# GUAM POWER AUTHORITY

## AMENDMENT NO.: IV

INVITATION TO BID NO.: GPA-047-25

### T-7 TRANSFORMER REPLACEMENT (DESIGN-BUILD)

7/18/2025: PITI S/S, EXISTING AC PANELBOARD AT 13.5 KV SW.GR  
ON CUBICLE NO. 1

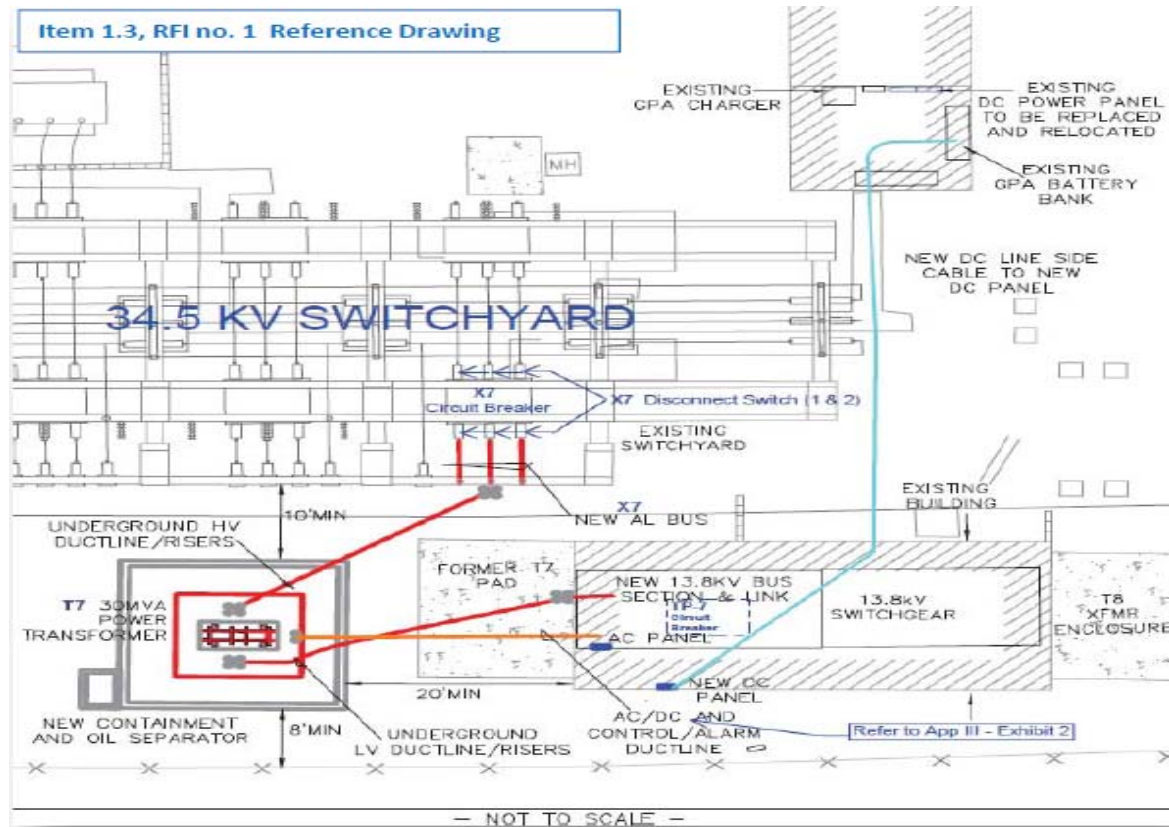
- \* 1. Piti S/S, Existing AC Panelboard at 13.5 KV SW.GR on Cubicle No. 1 (**ATTACHMENT A**)

15. Pls clarify what ampere rating is required for two-pole breakers.

- As per ***Scope of Work – 1.9 – T7 Auxiliary Power AC Panelboard – b, Page 96 of 1042.***
- Refer to **INCLUSION NO. 1** above.
- Refer to ***Appendix III – Exhibit 2 – Local Control Panel for 18/24/30MVA Transformer, Pages 396 thru 413 of 1042.***
